PROPOSED FIRST FLOOR PLAN
 SCALE 1:50 @ A1, 1:100 @ A3

REV	DATE	NOTES
moreno:masey architects+interiors		
t +44 20 3142 6554 www.morenomasey.com		
PROJECT 31 WILTON CRESCENT		
CLIENT LONDON REALTY		
DRAWING TITLE PROPOSED FIRST FLOOR PLAN		
SCALE 1:50 @A1,1:100 @A3	DATE DEC 17	DRAWN JR
PROJECT NO. 14028	DWG NO. 1912	CHECK MR
		REVISION P3

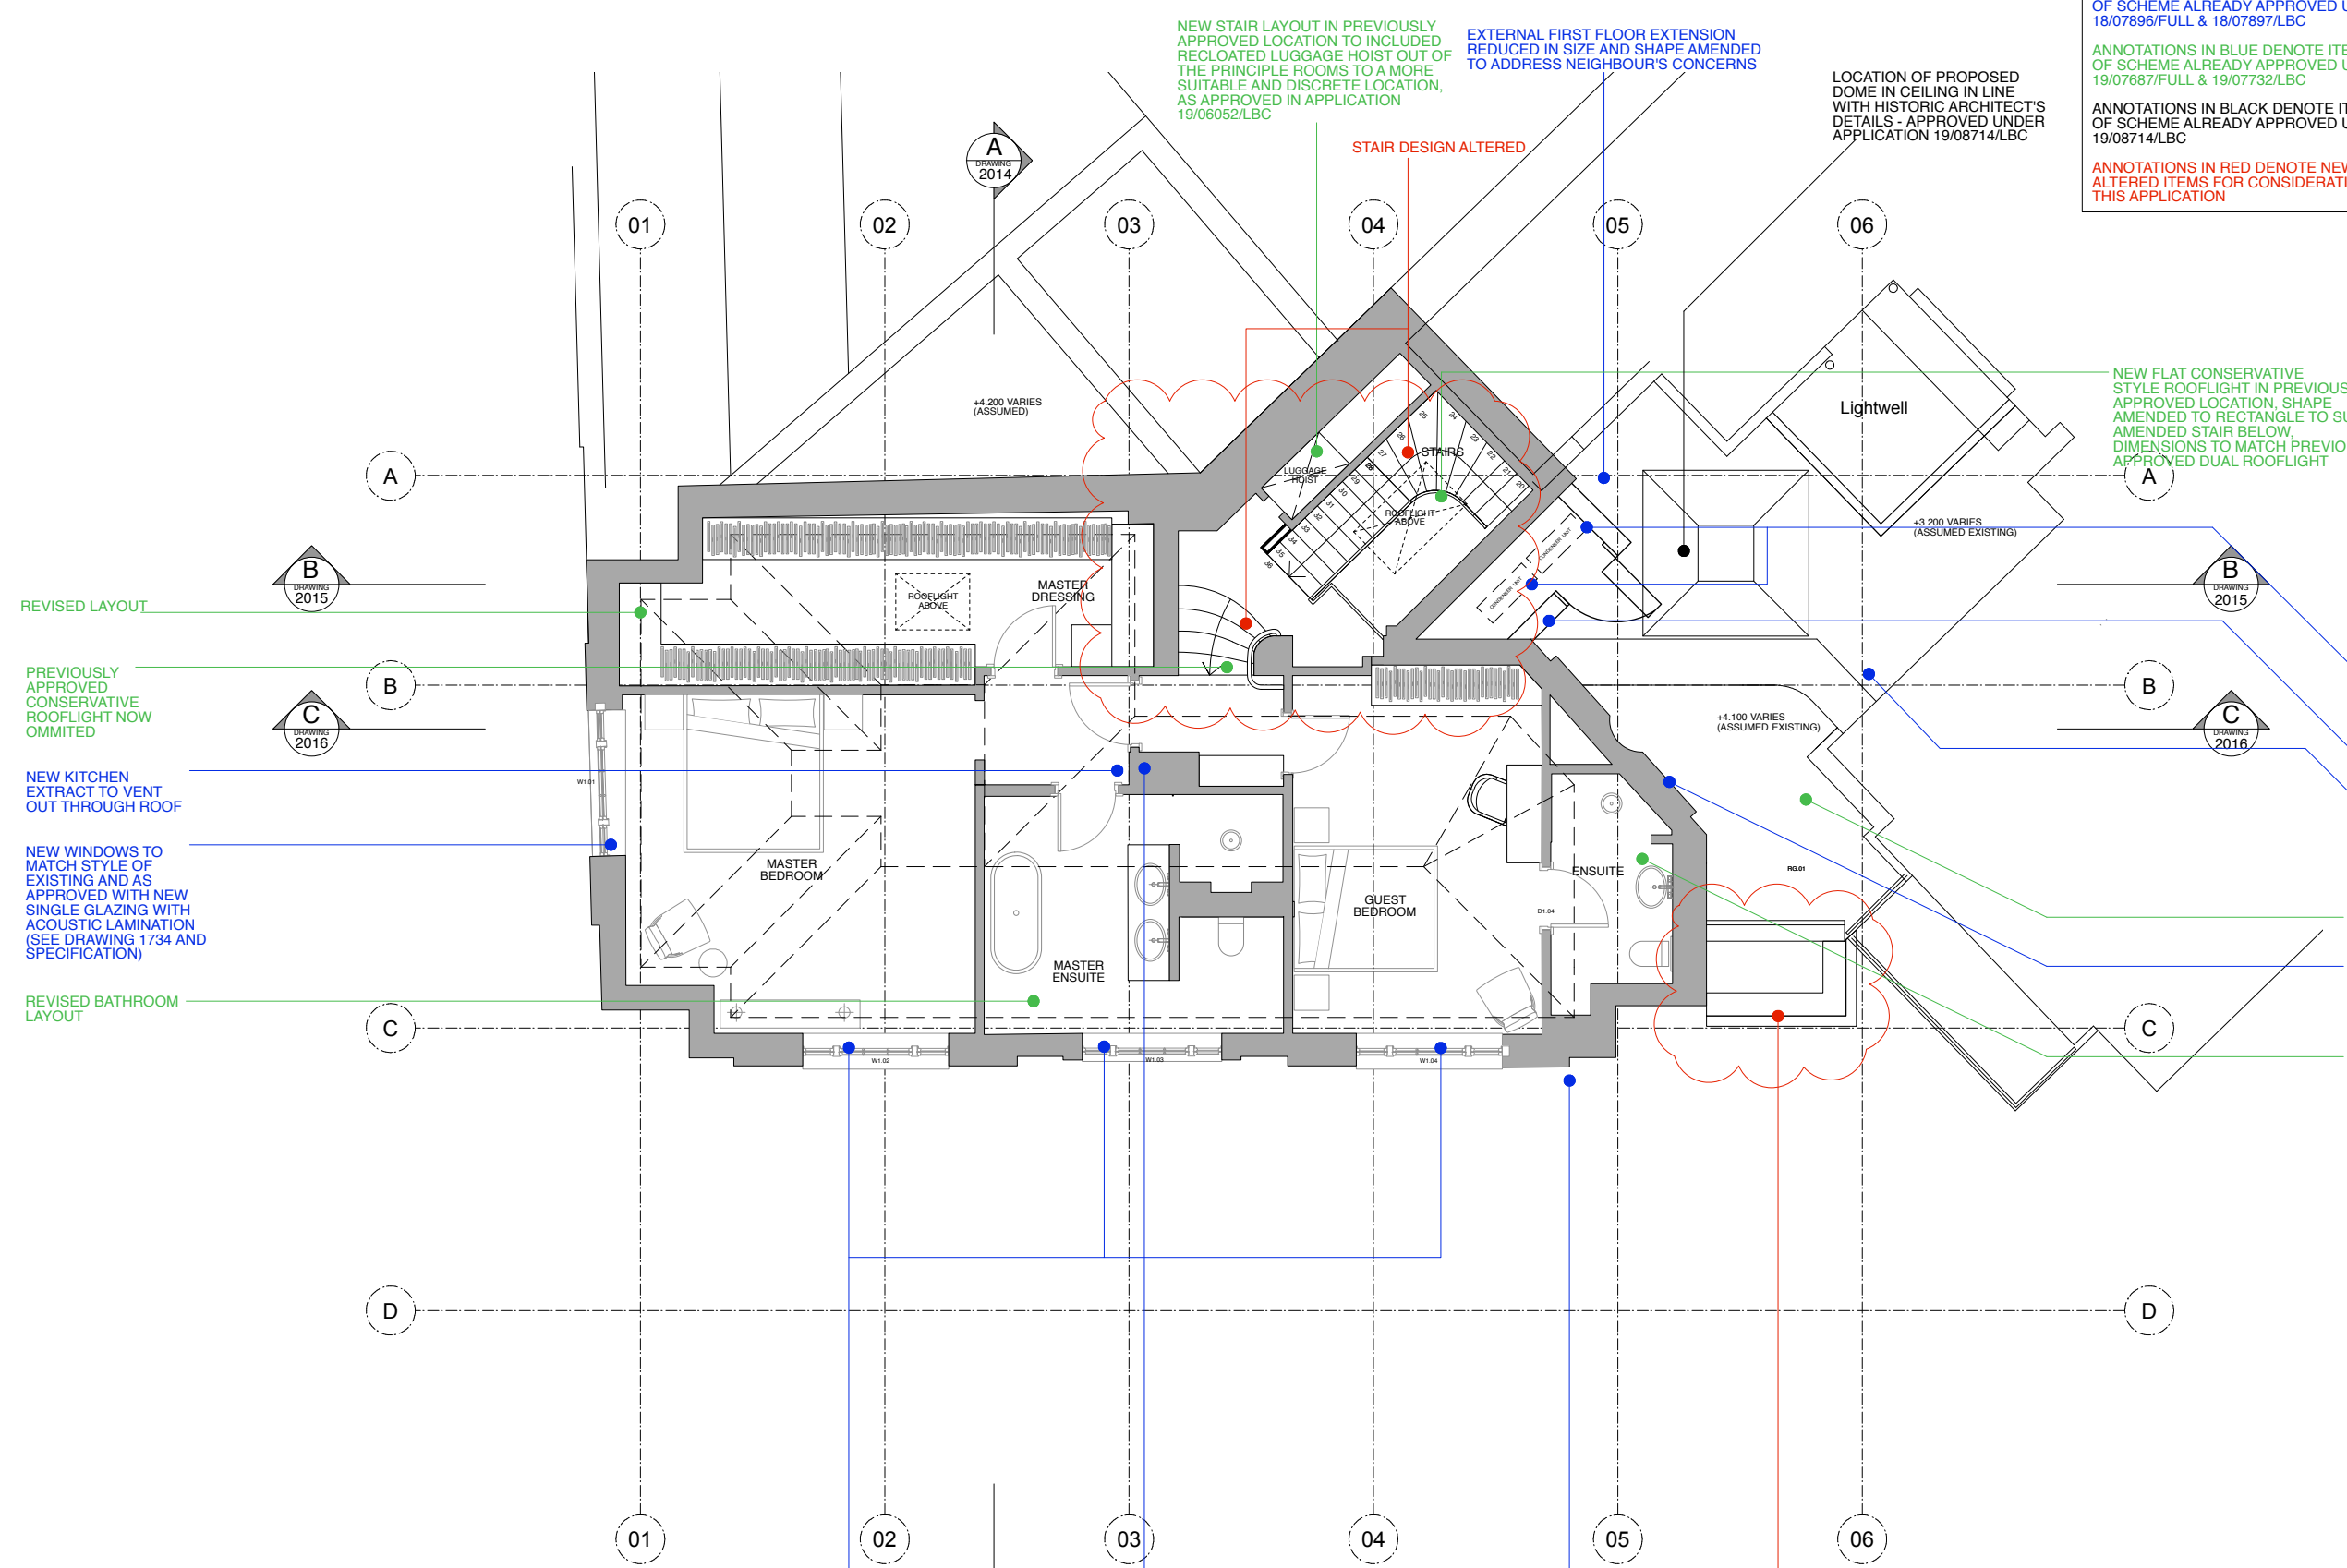
NEW STAIR LAYOUT IN PREVIOUSLY APPROVED LOCATION TO INCLUDED RELOCATED LUGGAGE HOIST OUT OF THE PRINCIPLE ROOMS TO A MORE SUITABLE AND DISCRETE LOCATION, AS APPROVED IN APPLICATION 19/06052/LBC

EXTERNAL FIRST FLOOR EXTENSION REDUCED IN SIZE AND SHAPE AMENDED TO ADDRESS NEIGHBOUR'S CONCERNS

STAIR DESIGN ALTERED

NEW FLAT CONSERVATIVE STYLE ROOFLIGHT IN PREVIOUSLY APPROVED LOCATION. SHAPE AMENDED TO RECTANGLE TO SUIT AMENDED STAIR BELOW. DIMENSIONS TO MATCH PREVIOUSLY APPROVED DUAL ROOFLIGHT

REVISED LAYOUT

PREVIOUSLY APPROVED CONSERVATIVE ROOFLIGHT NOW OMITTED

NEW KITCHEN EXTRACT TO VENT OUT THROUGH ROOF

REVISED BATHROOM LAYOUT

2X AC CONDENSER UNITS. PROPOSED STRENGTHENING OF EXISTING ROOF STRUCTURE UNDER UNITS AS REQUIRED BY STRUCTURAL ENGINEER.

NEW ACOUSTIC LOUVRE ENCLOSURE TO ACOUSTIC CONSULTANTS SPECIFICATION

MAINTENANCE ACCESS LADDER RUNGS FIXED ON WALL AS PREVIOUSLY APPROVED APPROXIMATE DIMENSIONS 200MM X 350MM. RELOCATED FROM PREVIOUS APPROVAL.

PREVIOUSLY PROPOSED ROOFLIGHT NOW OMITTED

NEW SPLAYED WALL (REFER TO DRAWING ELEVATION 3 1719) AMENDED TO ADDRESS NEIGHBOURS CONCERNS.

REVISED BATHROOM LAYOUT

NEW FLUE EXTENSION AND LINING FROM EXISTING FIREPLACE ON GROUND FLOOR TO EXTEND INTO PREVIOUSLY APPROVED CHIMNEY AT ROOF LEVEL.

REPLACE EXISTING CORNICE WITH NEW CORNICE TO MATCH ORIGINAL DETAIL (AS SEEN ON 1-2 GROSVENOR CRESENT)

REDUCED PORTICO - REFER TO DRAWING WCP 006D AND HERITAGE STATEMENT FOR FURTHER DETAILS
